Service Information

HR7710
HR7712

DAP145

Electronic circuit / Housing Items 5 and 4

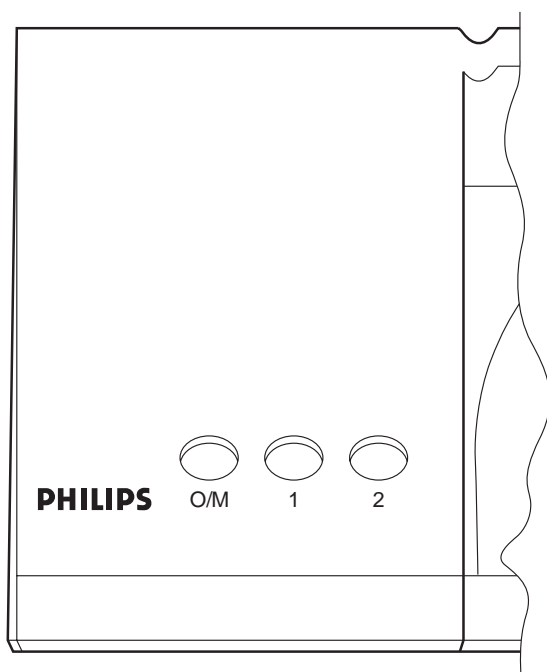
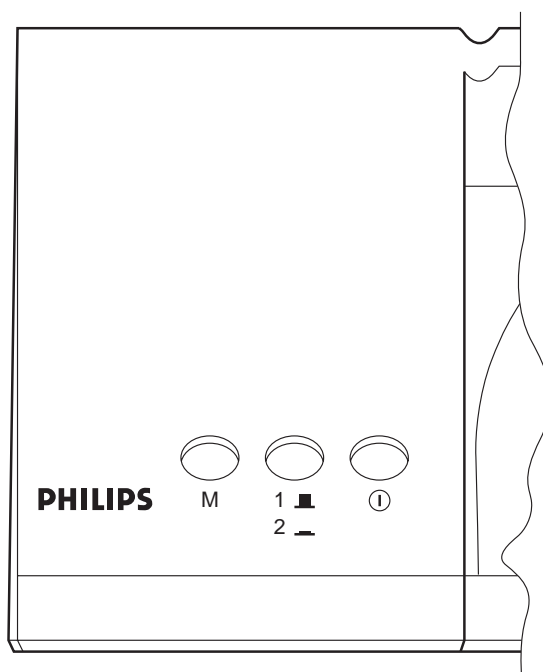
Alterations: From serial number 7014 on the functions of the keys were modified (see illustration below) and thus the housing graphics and the switch's internal structure were modified.

Old condition

with switch 4822 277 11644
and housing 4822 441 11836

New condition

with switch 4822 277 11697
and housing 4822 441 11999

Interchangeability: Both the modified housing and the modified switch (new condition) cannot be used in old sets (former condition).

Housing: Only the new version will be available; in order to use it in old sets the switch must also be replaced.

Switch: Both versions will be available (old and new conditions).
